NUCLEAR REGULATORY COMMISSION

Title: Advisory Committee on Reactor Safeguards
Plant License Renewal Subcommittee

Date: Wednesday, April 4, 2007

5 This is a meeting of the Plant License
6 Renewal Subcommittee. I'm Otto Maynard, Chairman of
7 the Pilgrim Plant License Renewal Subcommittee.

3" instrumented drain line alarms in control room

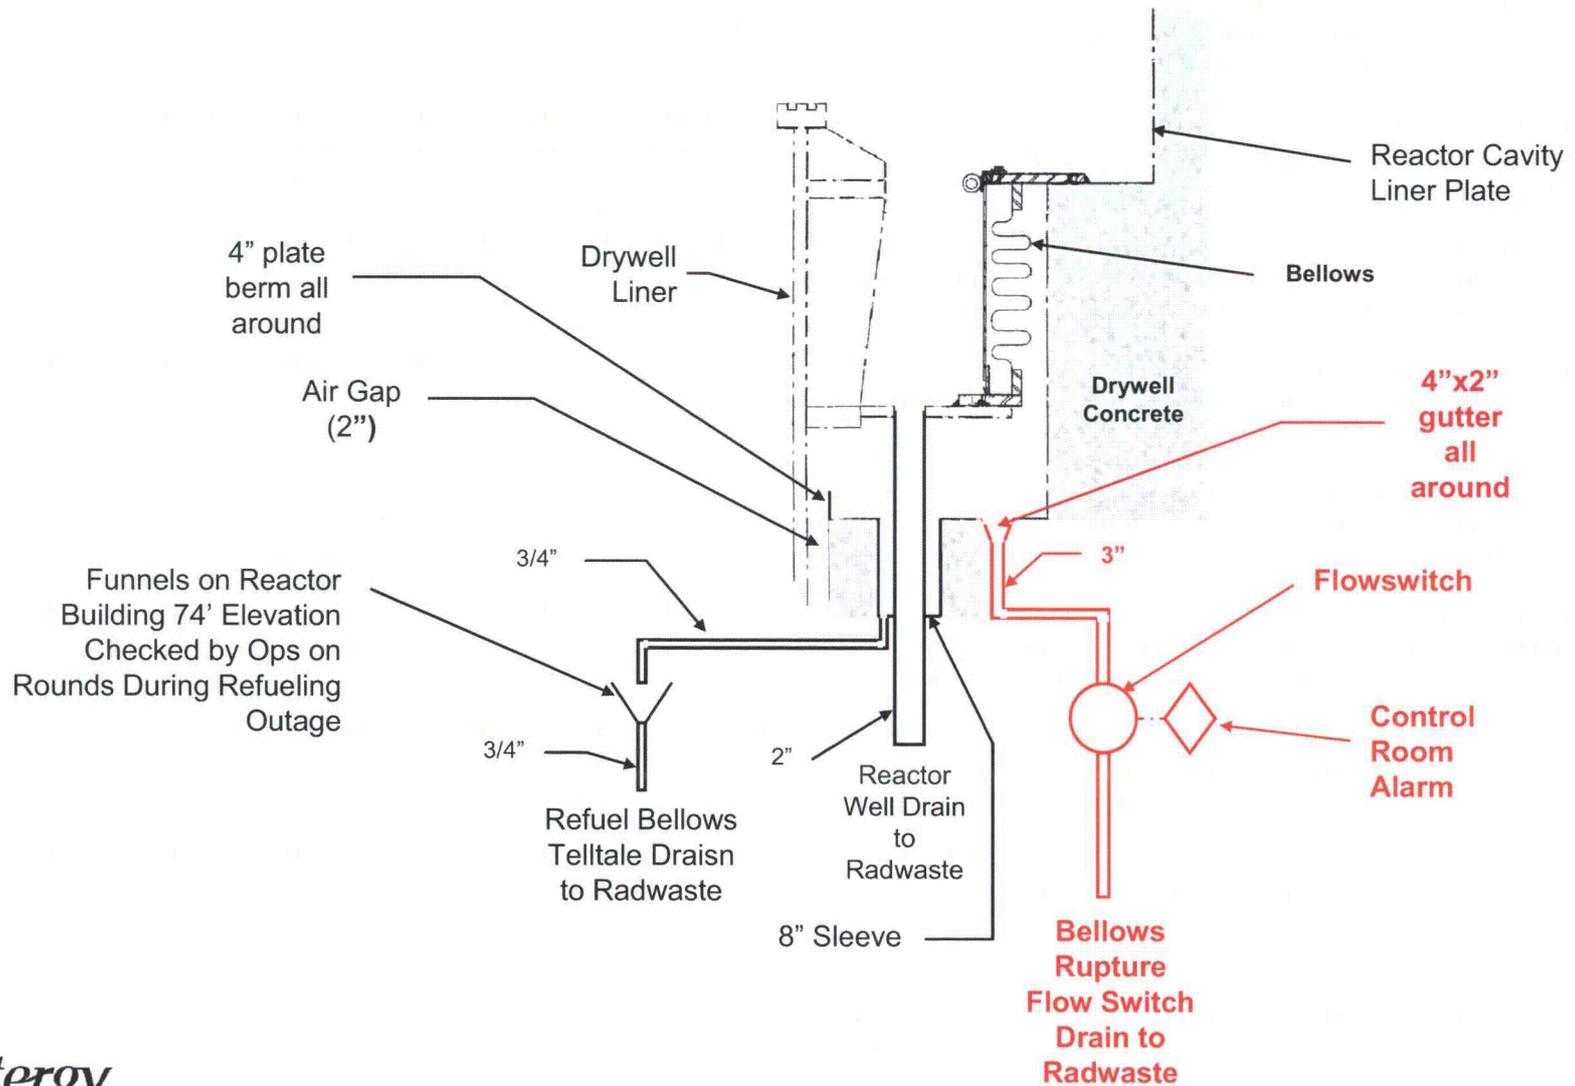
2 MR. BETHAY: We do a surveillance on it
3 every operating cycle to verify that there's flow and
4 that the flow switch is functional. And that's what
5 was identified in late 2005 that the flow switch
6 failed a surveillance.

21 MEMBER BONACA: You said at the beginning
22 that the flow switch in the control room activates at
23 8 gpm. And a question I have for that system, I think
24 is a three-inch pipe, I guess it can -- going much
25 more than 6 gpm, right?

Four 4" upper sand cushion drains drain into collection devices and are monitored at beginning and end of each RFO

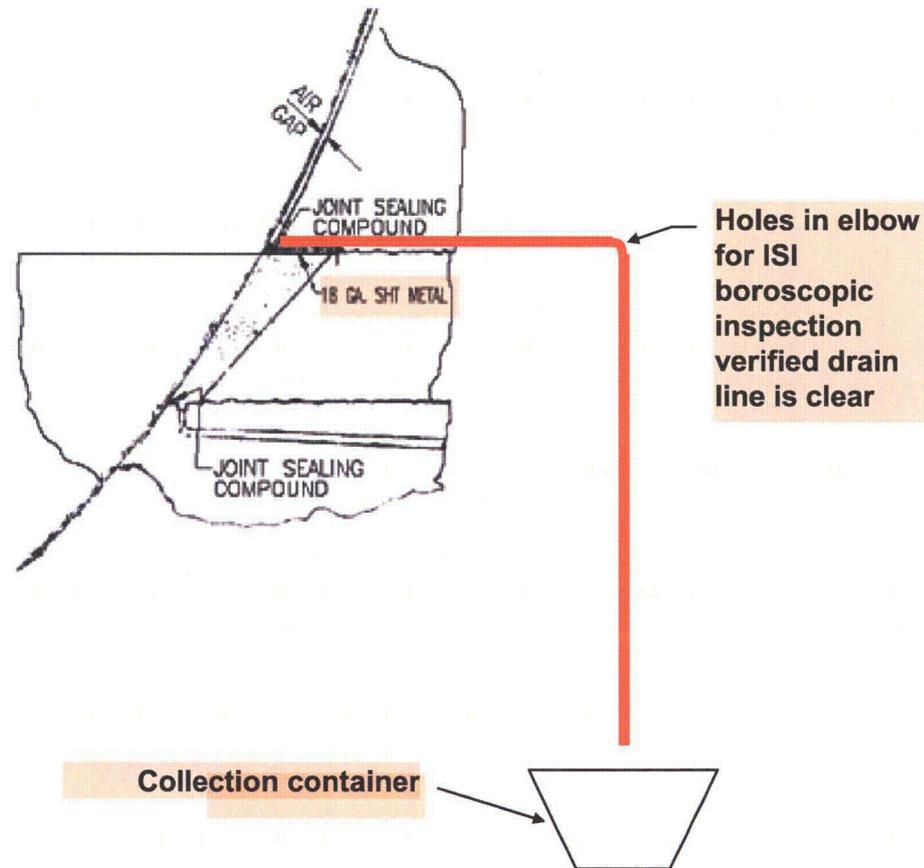
1 you could hypothesize would run down the air gap to
2 this is the 9 foot 2 elevation, the bottom, the floor
3 of the primary containment structure. And it would be
4 collected by four four-inch drain lines that sit just
5 above an 18 gauge sheet metal plate and drain above
6 the sand pocket region into collection containers that
7 are on the torus room floor.

18 And just as another point of interest,
19 just back in the '80s when the concern was raised
20 about corrosion of the primary containment structure,
21 Pilgrim went into these four-inch drain lines and
22 drilled holes in the elbows and did visual inspection
23 to verify, first, that those lines were clear and
24 unobstructed, and second to do a kind of brief visual
25 inspection of the liner that they could see at the end

Four sand cushion drains provide further detection capabilities

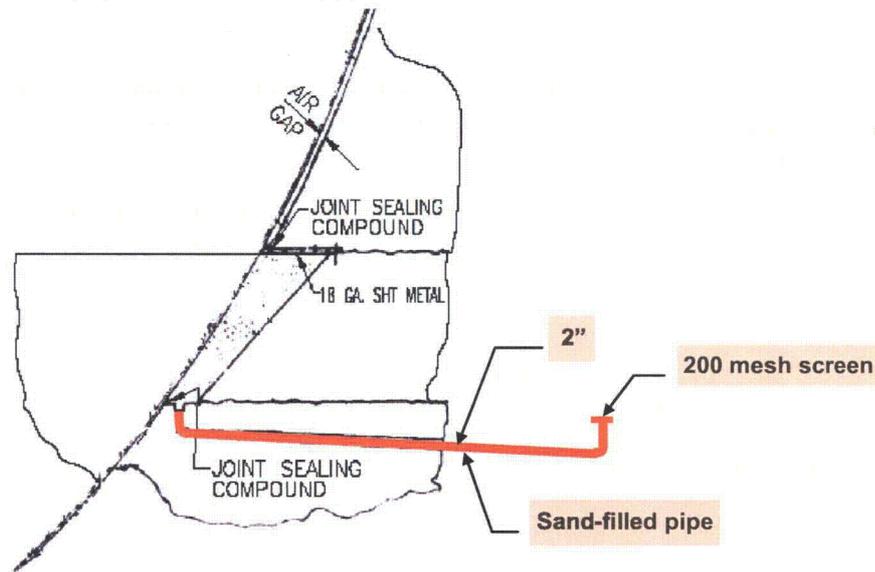
18 MR. BETHAY: But if this drain didn't work
19 for whatever reason and water made it into the sand
20 pocket region, there are four bottom of sand pocket
21 drains that would provide the final barrier of
22 defense.

Bay 10

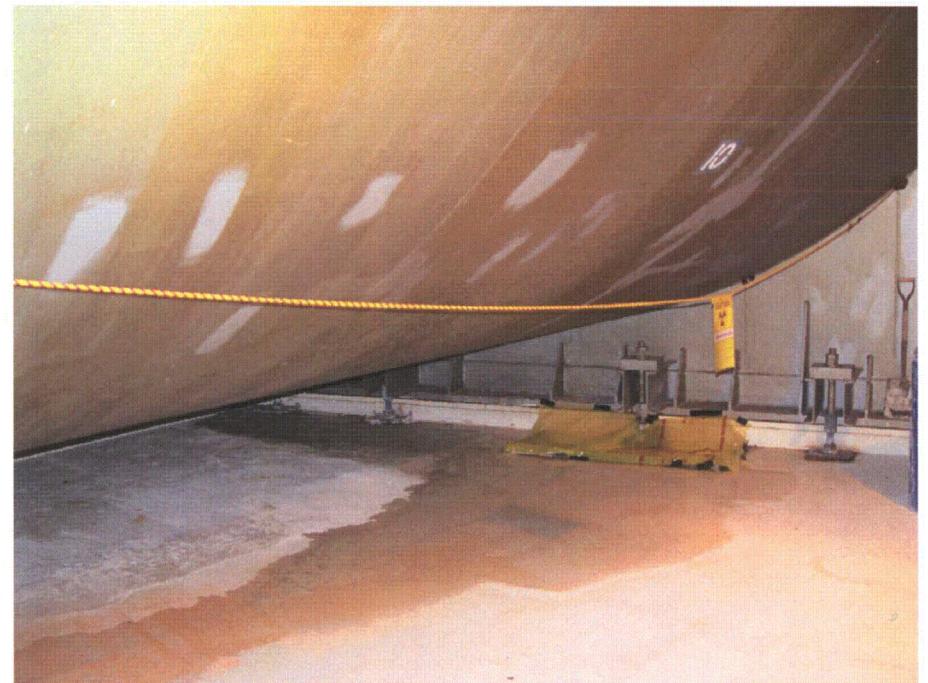
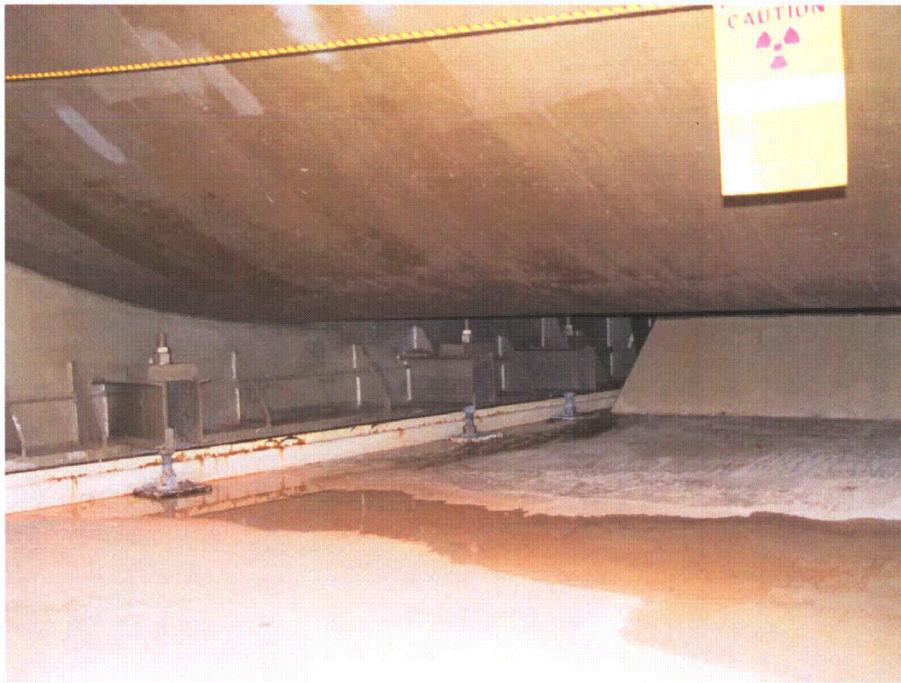
4 MR. BETHAY: No, sir. The water on the
5 floor just -- and let me go ahead and click to -- I'm
6 going to show you the worst picture. This is the
7 worst picture of the 16 torus bays.

16 MR. BETHAY: What you see is this water on
17 the floor, you know we believe is emanating from
18 around some of these base plates. This structure, and
19 I'll show you in some other pictures, is the Mark 1
20 containment modification phase II torus saddle that
21 was installed. There are 16 of these around the
22 plant, each held down by eight rock bolts. They were
23 installed to hold the torus down in the event of a
24 complete blowdown to prevent pool swell, chugging
25 loads from the torus lifting up.

1 What we've seen historically is water on
2 the floor around one or more of these base plates.
3 I'll show you some other pictures. Now --

23 I just want to set this to kind of set the
24 stage to show that you of the 16 bay areas of the
25 torus, this is the worst one. So anything else that

1 I show you is less significant than what you see in
2 this picture in terms of what it looks like.

3 So what we've concluded is that the source
4 of the water is ground water. It seeps in under
5 hydraulic pressure. And I'll talk a little bit about
6 that as I show where the water table is relative to
7 the plant.

Bay 9

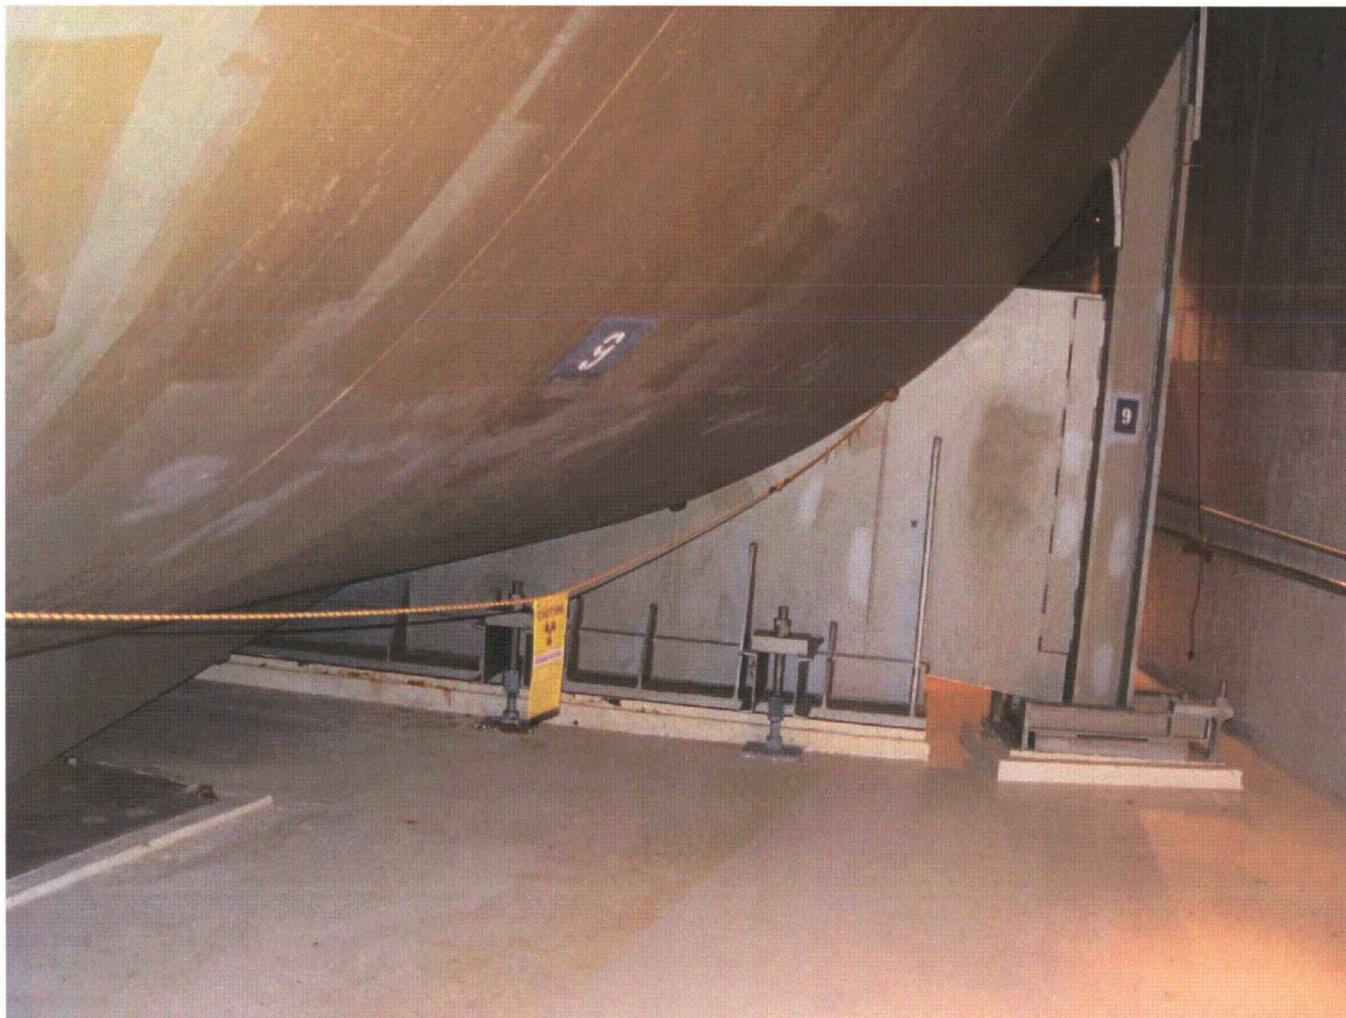
4 MR. BETHAY: I'll show you. Let's go to
5 bay 9. This is a slide.

10 In the phase one of the Mark 1 containment
11 modifications this support structure was modified to
12 provide not support capability but hold down
13 capability.

Bay 10

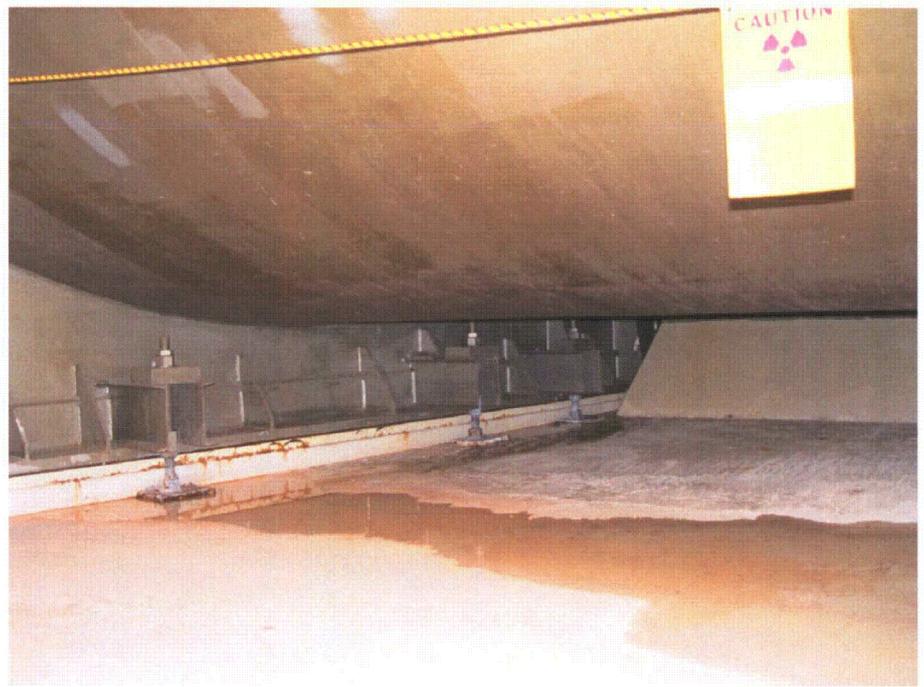
7 MR. BETHAY: We'll be doing it right now.
8 Right. The maintenance request to do this is in the
9 planning stage. And it will look at a sampling of the
10 bolts in bay 10, because that's the worst. And then
11 we'll expand scope if necessary based on whatever we
12 find when we do that inspection.

19 That we'll verify the condition of the
20 bolts by sample in bay 10, is what we've lined out.
21 We'll do that prior to extended operation, and
22 actually that's --
